Document: Draft, Phase 1 Evaporation Ponds Characterization Data Summary Report
Update, Anaconda Copper Mine Site – Yerington, Nevada, August 18, 2017

Reviewer: Yerington Paiute Tribe

Figure 1. Elevation of pond bottom/sediments at two locations in the northern set of ponds compared to groundwater levels in nearby shallow wells. Well log presented in Figure 2.

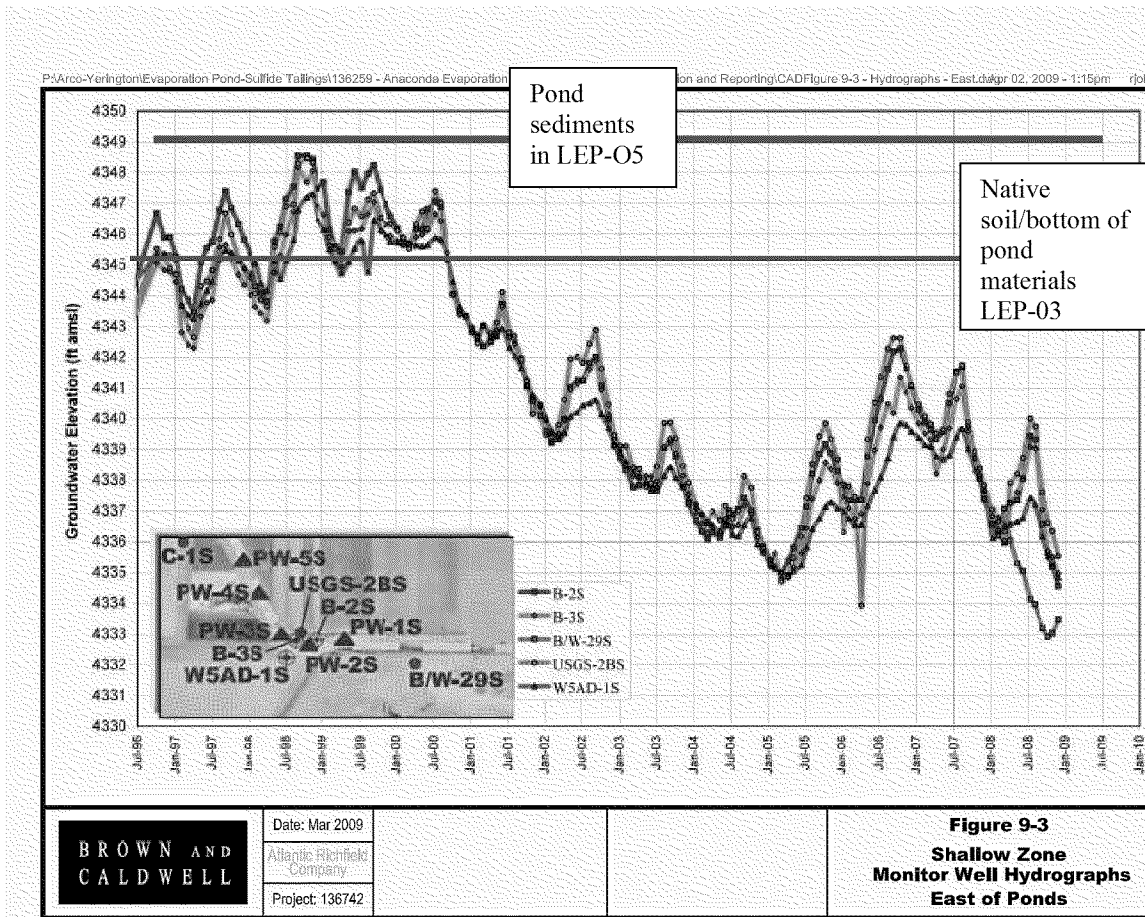
8. Section 3.4 makes the assumption that transport is only due to accumulation of precipitation in the ponds facilitating downward migration of COCs. Groundwater levels have historically been at elevations associated with sediments in the ponds with up to 5 feet of sediments potentially within the saturated zone (Figure 1 through Figure 3).

These data indicate that even with pumping of the shallow groundwater from multiple nearby downgradient locations, groundwater has recently been in contact with pond sediment. Historic data indicates that is not an isolated event (Figure 3). Adding to this, these groundwater measurements are from lower pit lake levels. As the pit lake water levels increase, groundwater will follow increasing the incidence of evaporation pond sediments saturated by rising groundwater.
